Addendum No. 1
Stanley-Jensen Stadium Lighting Improvements
City of Prattville Bid No. 022-008
City of Prattville
Civil Southeast Project No. 22P2402.1

Clarification

Revised Construction Plan Sheets Attached

E-3

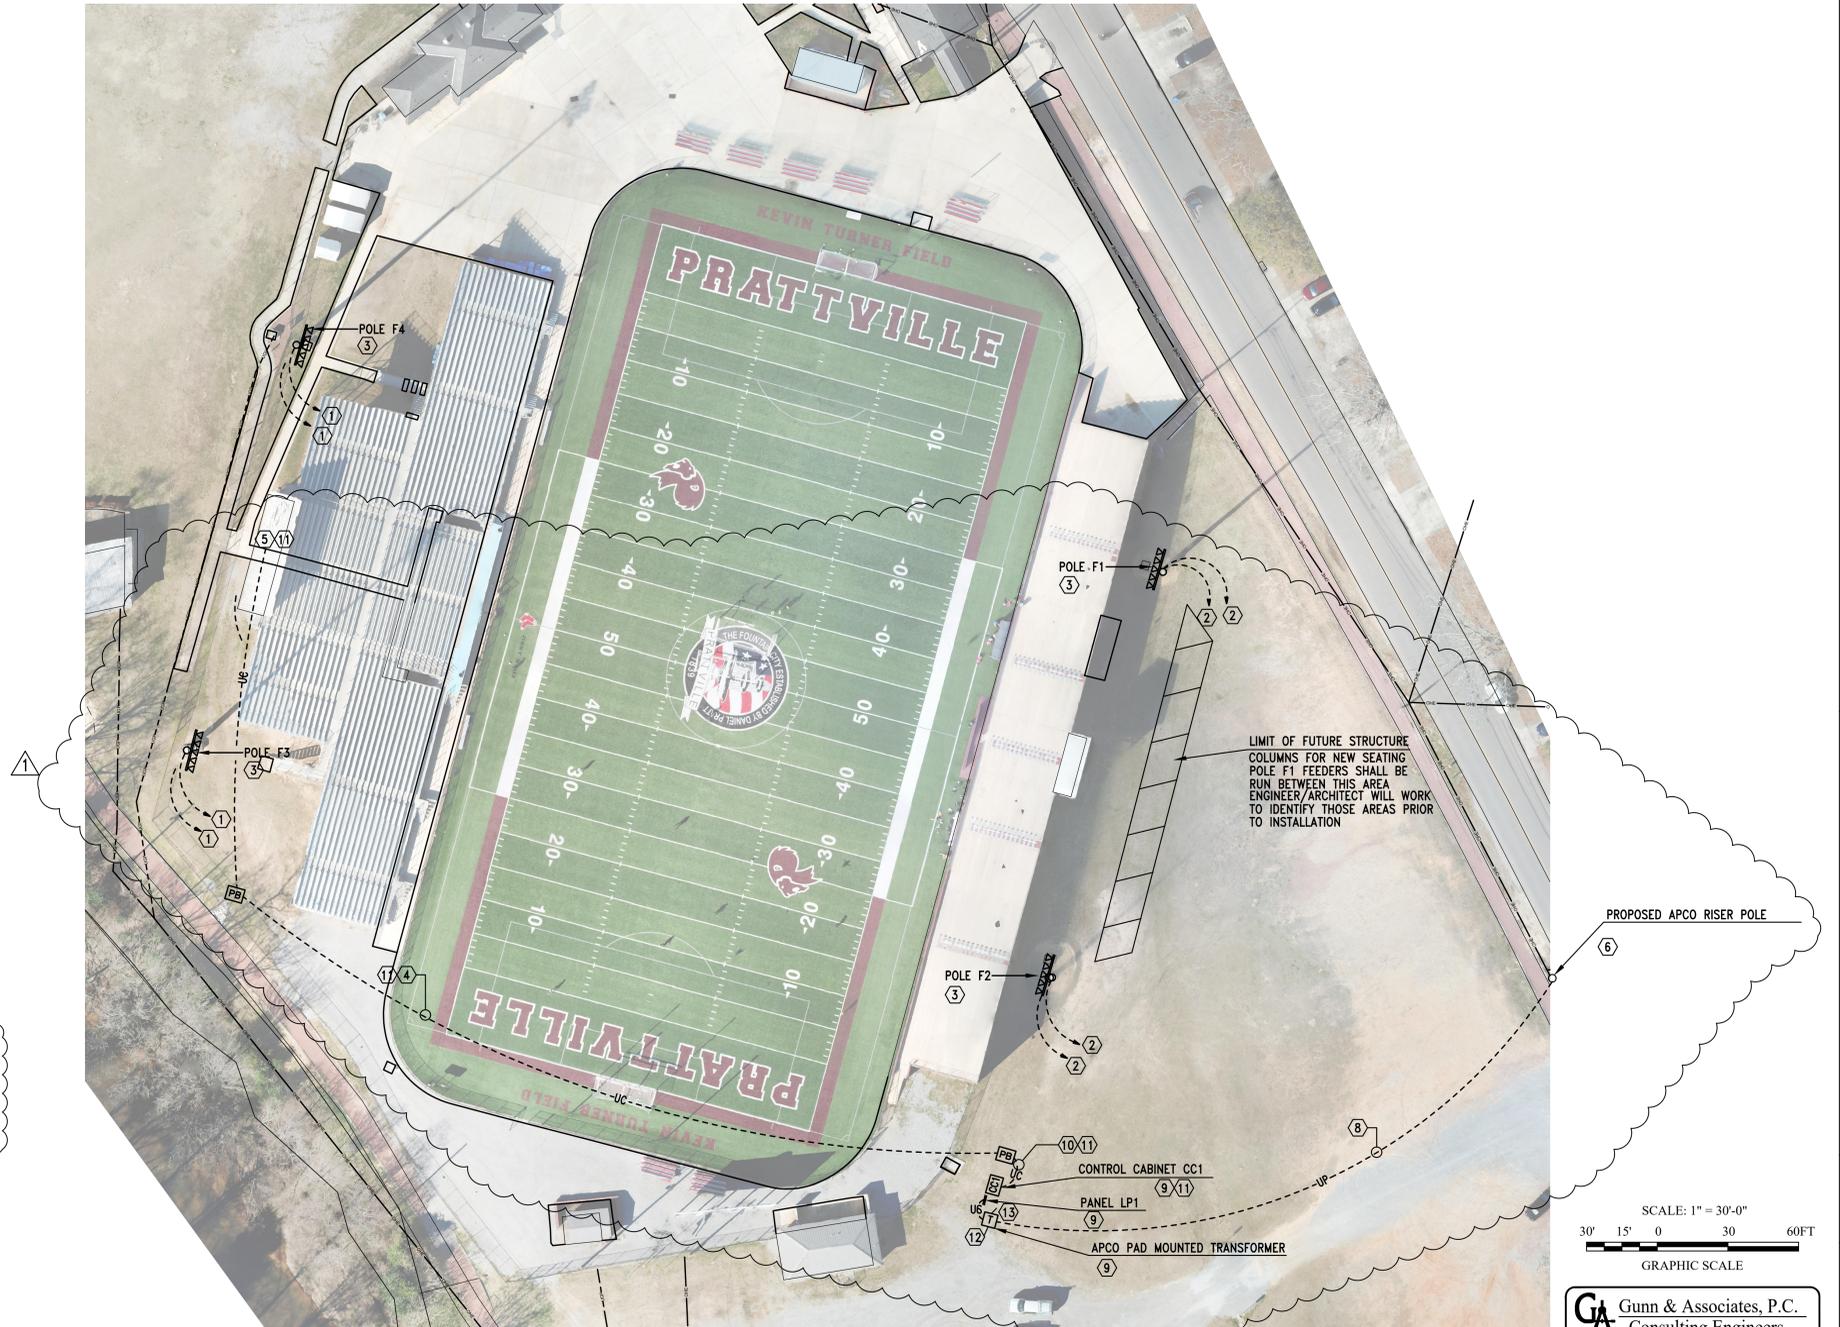
- The Contractor shall replace the existing sheet E-3 with the attached revised sheet E-3 revised April 12, 2022.

PRIOR TO INSTALLATION CONTRACTOR SHALL COORDINATE WITH PHASE 2 CONCEPT OF STADIUM TO MOUNT COMMUNICATIONS PULLBOX, TRANSFORMER, PANEL LP1 AND CONTROL CABINET CC1 BETWEEN FUTURE HANDICAP RAMP AND FUTURE SIDEWALK IN THE GENERAL AREA INDICATED ON THIS PLAN.
